# Access Compliance Report

## Public Rights-of-Way

| Intersection ID: N/A                    | Main Street: NATIONS_FORD_RD | Cross Street: N/A                       | Location: SW           |
| ADA ID: 67F3ACFA6FDC                    | Ramp Type: PerpDiag          | Initial Pass/Fail: Fail                 | Overall Compliance: No |

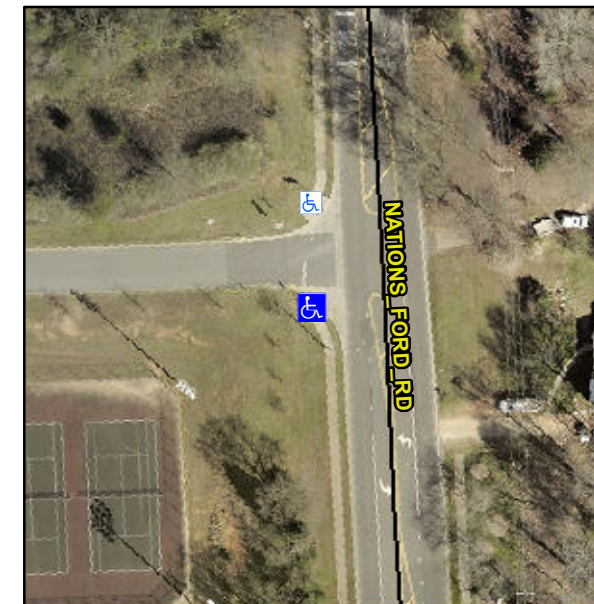
**Not Found, R304.5.1, R304.5.3**

| Compliance | Description           | Data  | Compliance | Description                 | Data |
|------------|-----------------------|-------|------------|-----------------------------|------|
| No         | Ramp Width (in)       | 47.0  | No         | Ramp XSlope (%)             | 2.1  |

**Remove & Replace Curb Ramp With Two New Directional Ramps or Equivalent.**
